TC_TH

Description Redesign

RFID_UNI
2810b
V 0.1

2.2.1 General Changes to existing design

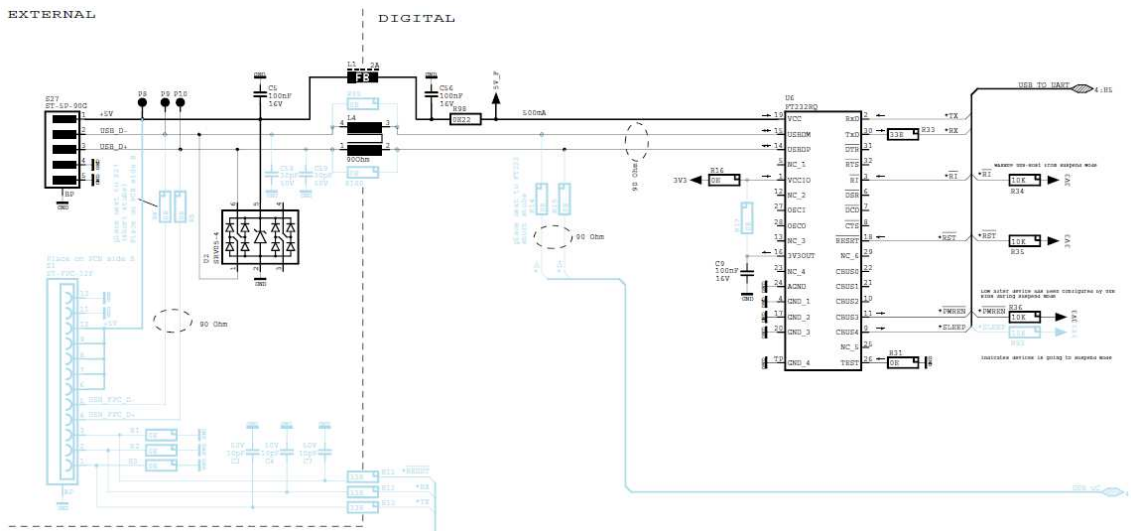
The following changes have been made to internal job number 2810a → 2810b in the schematic in all versions.

- Connector S1 (12-P) removed; only one more connection option (S27 / 5-P)
- IC-U25 ISL83072 (RS485 transceiver) added
- Control line (EN) between U4 (LPC11E6x) and RFID-Chip U5 (TRF7970A) was pin swapped at U4 from pin #30 to pin #25. The reason for this pin swap is that the previously existing EN output of the LPC11E6x is required for RS485 driver switching.

2.2.2 Differences in the versions

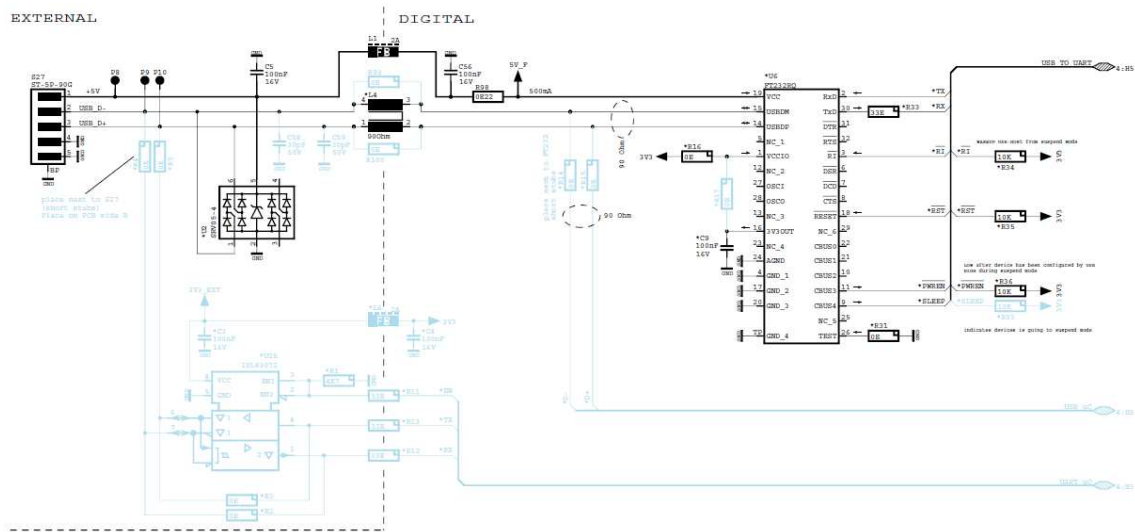
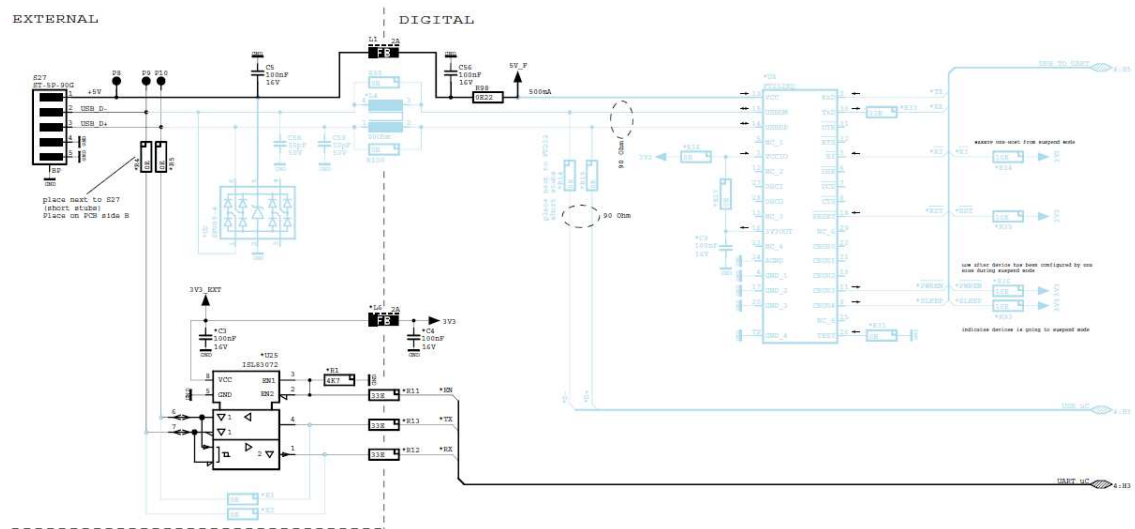
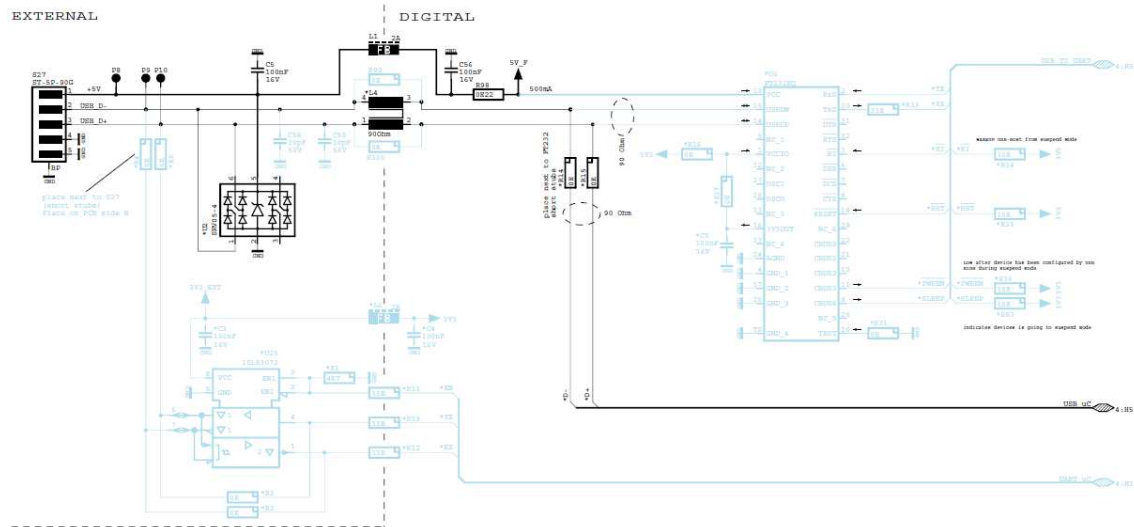
Two connectors for internal communication, no RS485 transceiver available.

Internal communication via USB (existing design; internal job number 2810a → 2810b)

V1: 5mm spacer soldered

V2: ident to V1, but 8mm spacer soldered

Internal communication via RS485 (NEW; internal job number 2810b)

2.3 Changes in Layout Design

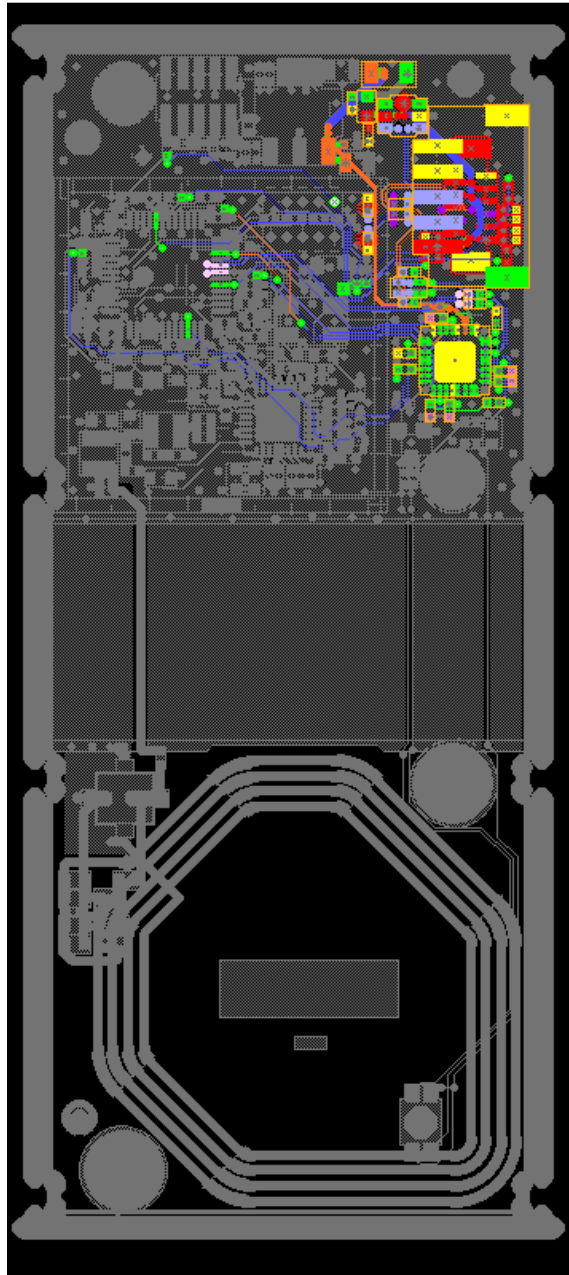
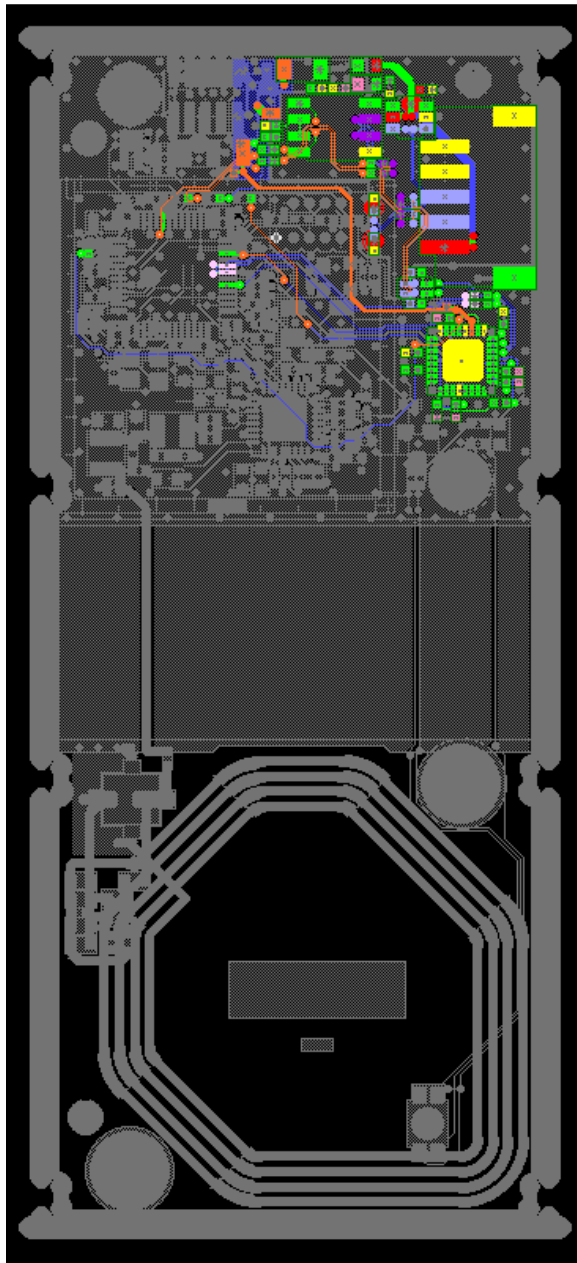
The following changes were made due to the adaption of the communication interfaces on the existing design.
